Model: Model AT-C1 Finisher (SR3010)		Date: 28-Jun-06	No.: RB792001
Subject: Firmware Release History (500-sheets Finisher)		Prepared by: H.Someya	
From: 1st Tech. Support Sec. Service Support Dept.			
Classification:	☐ Troubleshooting	☐ Part information	☐ Action required
	☐ Mechanical	☐ Electrical	☐ Service manual revision
	☐ Paper path	☐ Transmit/receive	☐ Retrofit information
	☐ Product Safety	☒ Other ()

Model: AT-C1 Finisher (SR3010)		Date: 18-May-09	No.: RB792002
Subject: SR3010 JAM		Prepared by: N.Yoshida	
From: 2nd Tech Support Sec. Service Support Dept.			
Classification:	☒ Troubleshooting ☐ Mechanical ☐ Paper path ☐ Product Safety	☐ Part information ☐ Electrical ☐ Transmit/receive ☐ Other ()	☐ Action required ☐ Service manual revision ☐ Retrofit information

Model: AT-C1 Finisher (SR3010)		Date: 24-Sept-10	No.: RB792003
Subject: Parts catalog correction		Prepared by: M. Kumagai	
From: 1st Overseas Tech Support Sec., 1st PQM Dept.			
Classification:	☐ Troubleshooting ☐ Mechanical ☐ Paper path ☐ Product Safety	☒ Part information ☐ Electrical ☐ Transmit/receive ☐ Other ()	☐ Action required ☐ Service manual revision ☐ Retrofit information ☐ Tier 2

Model: General		Date: 11-Ja

Photo 1

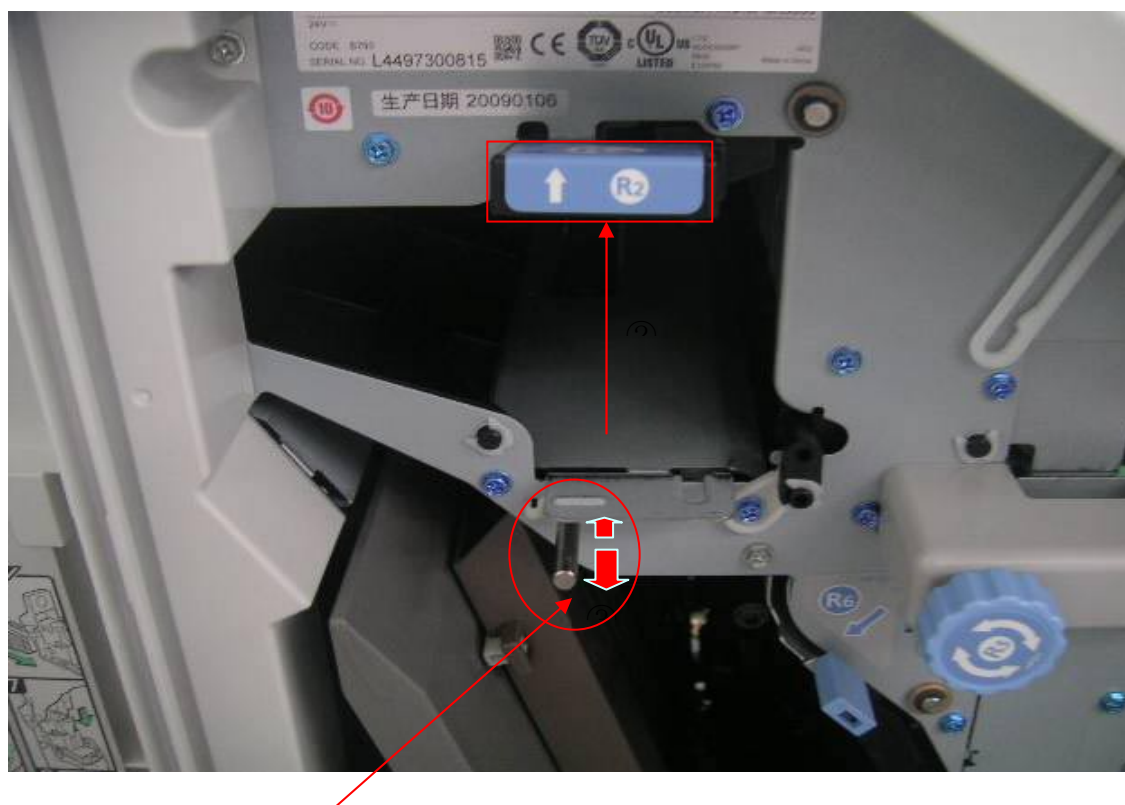
1. Open the front cover of the finisher.
 2. Pull up the "R2" shift guide.
 3. Move the shift roller shaft (circled in red) back and forth slowly. **Do not** turn the shaft.
- Note:** This will cause the shift motor (**B7935817**) to rotate.

IMPORTANT: Only move the shaft back and forth. **Do not** rotate.

Photo 2

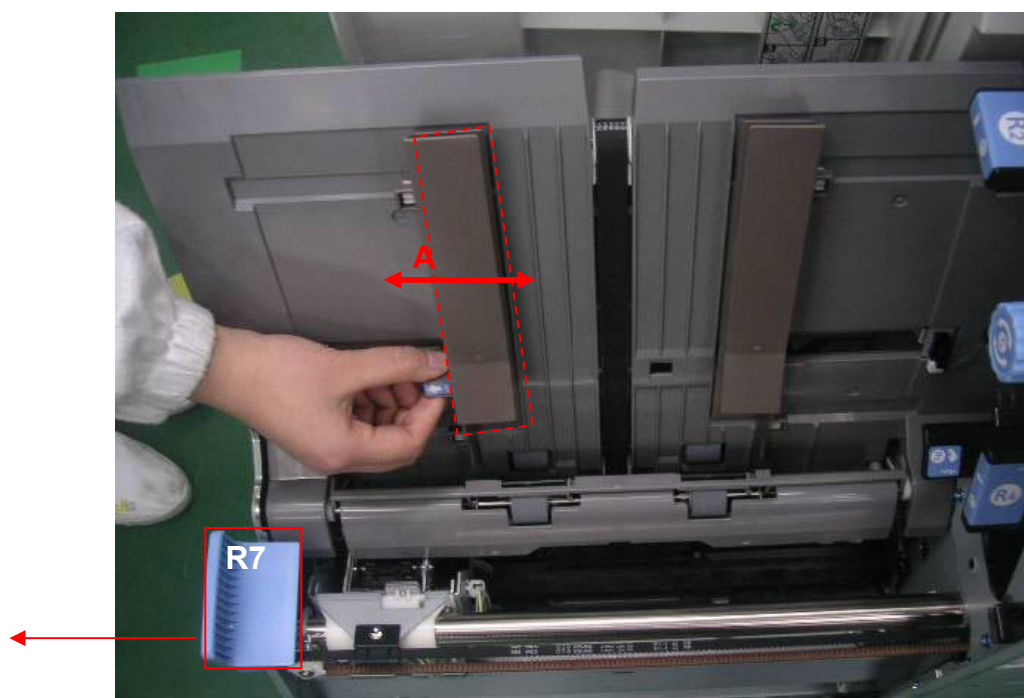
4. Pull out the stapler unit using the “R7” guide.
5. Move the operator-side jogger fence back and forth slowly three times within the range of movement shown by arrow “A”.

Note: This will cause the **first B7935815 motor** (“Motor 1” in Photo 5) to rotate.

Photo 5

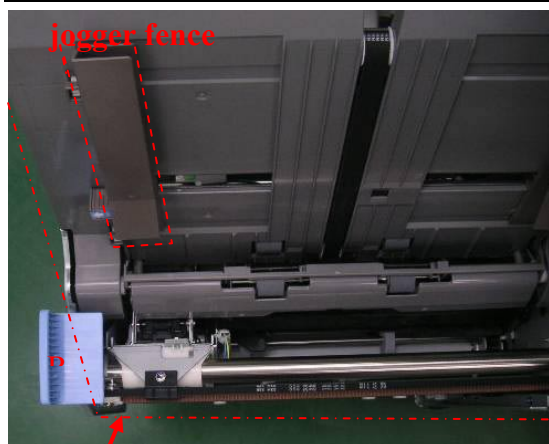
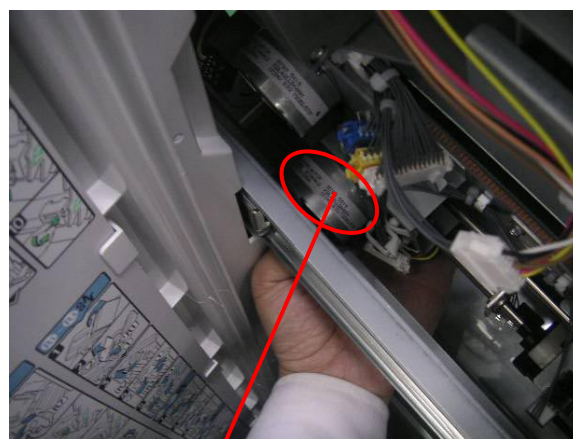
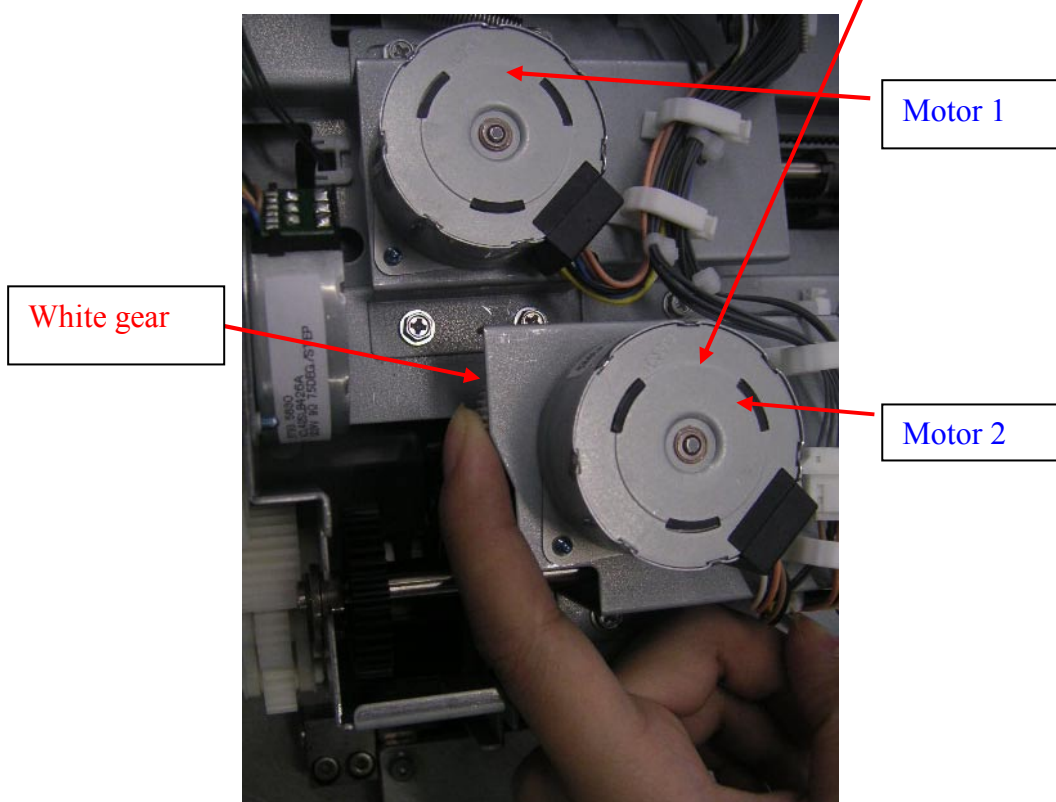
6. Confirm the following (See Photo 3):
 - The stapler unit is pulled out as far as it can go
 - The operator-side jogger fence is at its front-most position
7. Turn the white gear in Photo 5 clockwise 360 degrees.

Important: Reach under the rail to access the gear (see Photo 4).

Note: This will cause the **second B7935815 motor** (“Motor 2” in Photo 5) to rotate.

Photo 7

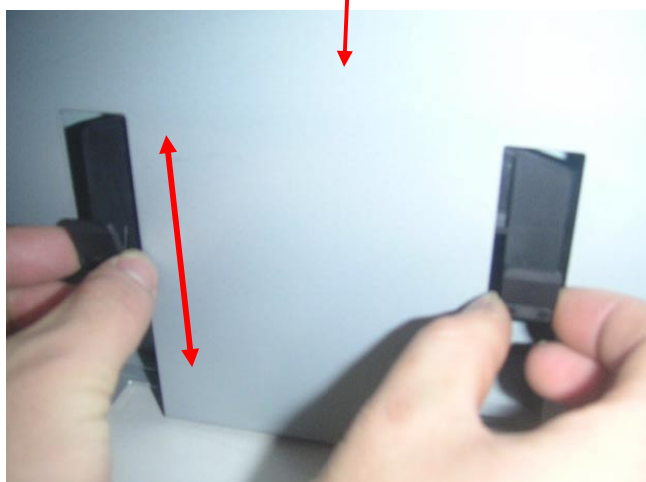
8. Open the black guide plate ("R11" in Photo 6).
9. Move the black grips up and down within the range of movement shown in Photo 7.
Important: Move both grips together at the same time, in the same position, and with the same amount of force.

10.Frame (B792)

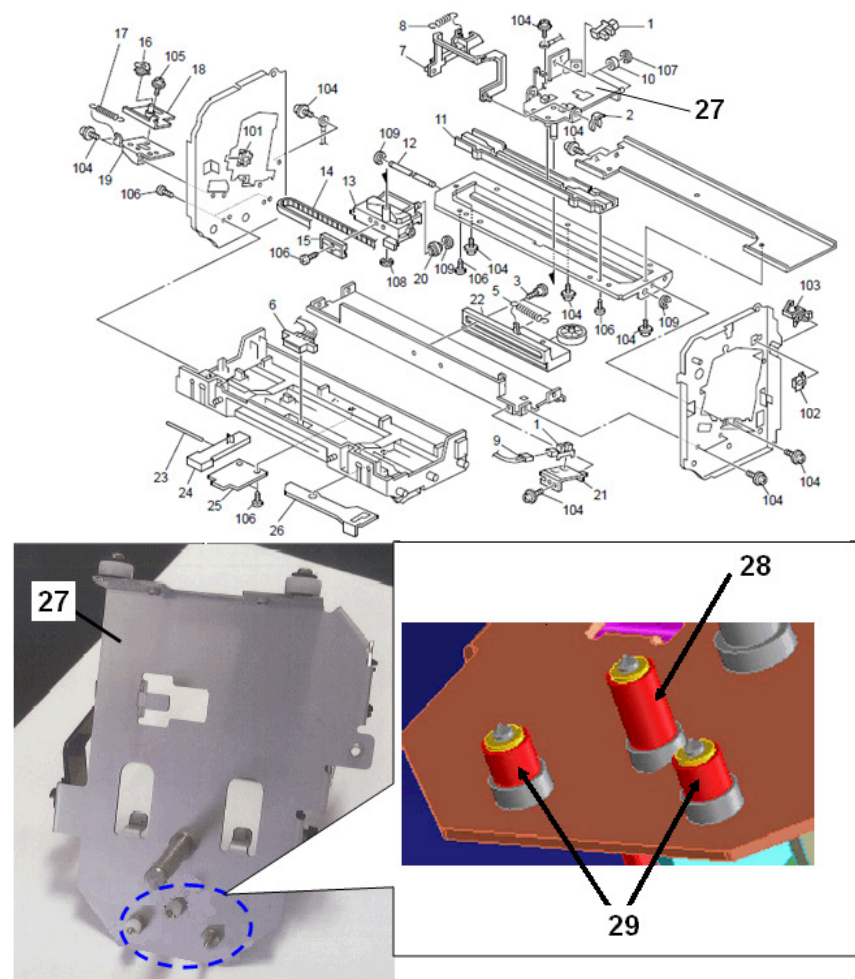
Change/Reason: The following parts were missing from the parts catalog.

Note: Index 27 does not contain index 28 and 29

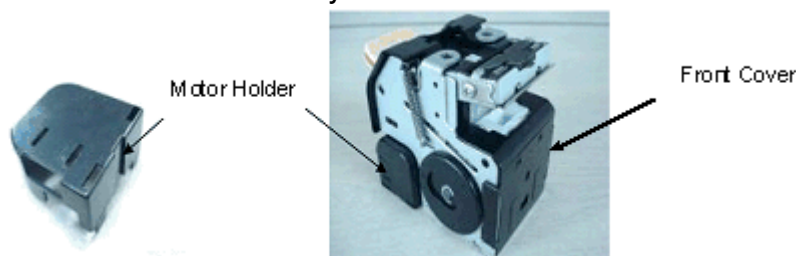
Some parts of the stapler unit (black resin parts shown below) contained PBDE material in excess of the limits set by the RoHS Directive.

The vendor of these parts used irregular materials during the manufacturing process.
 Production period: June to September 2010 (refer to the S/N table below)

The vendor of these parts will ensure that only approved materials are used on their production lines.

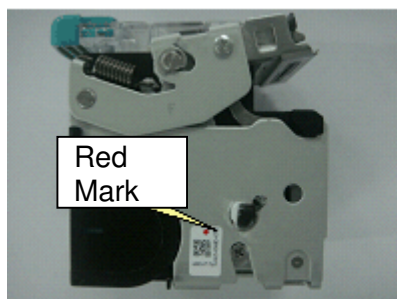
Important: Stapler units on some of these affected finishers have already been replaced with the normal ones. If there is a **red dot** on the stapler unit's label (see the photo below), you **do not need to replace** these units.

Replace the stapler unit.
